Technical Service Bulletin: TSB220023

Released Date: 16-Jan-2024

HDKAG Configuration Options for Isolated Neutral

Figure 2, Star (Wye) configuration for terminal connections

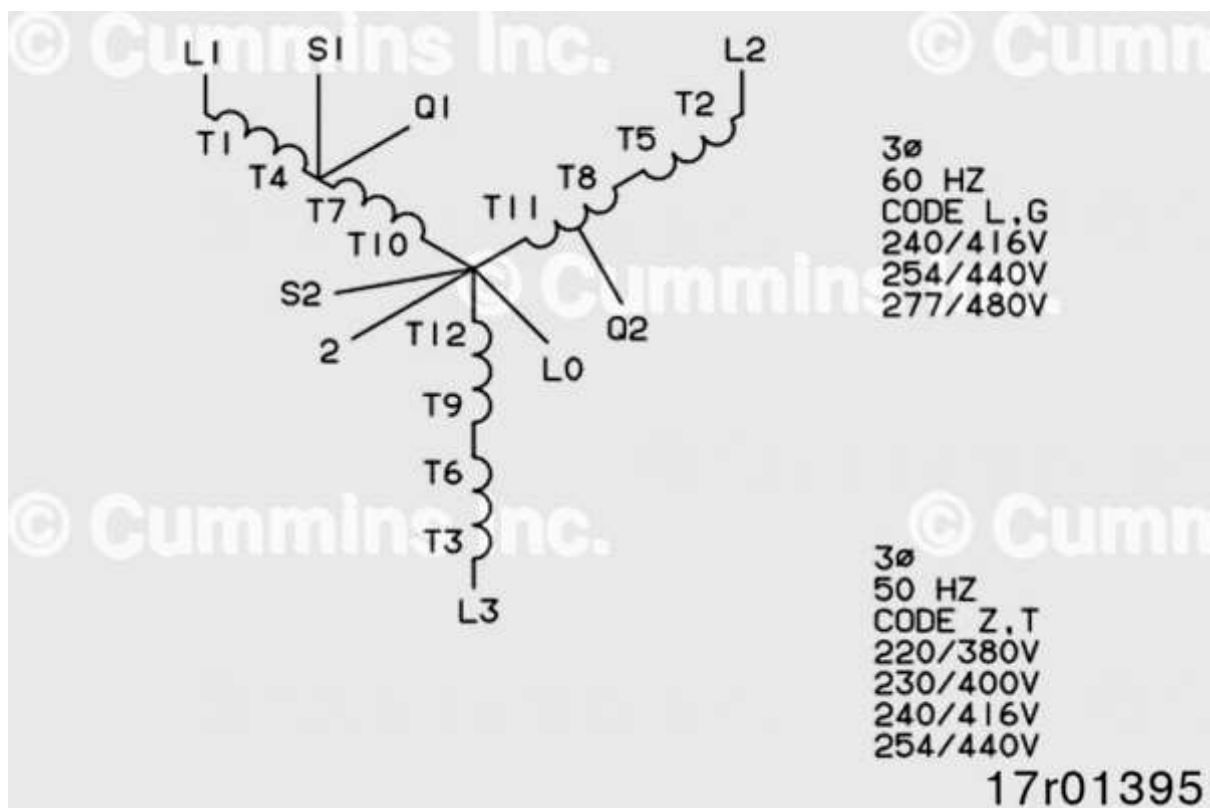
- No AC voltage is generated at rated RPM when configured to star (wye) terminal connection using an isolated neutral configuration on an HDKAG unit

- The field flash function of the generator set control does not function as intended on start-up, causing the generator set to not produce any output AC voltage at rated RPM.

1. Configure terminal connections to Series Delta and isolate neutral wire, given that the output voltage available from this configuration is acceptable.
2. If a Star (Wye) configuration is absolutely required, a work around solution has been deployed for field use. See service instructions below for further detail.

- Further implementation of a relay solution, as below, will be required.
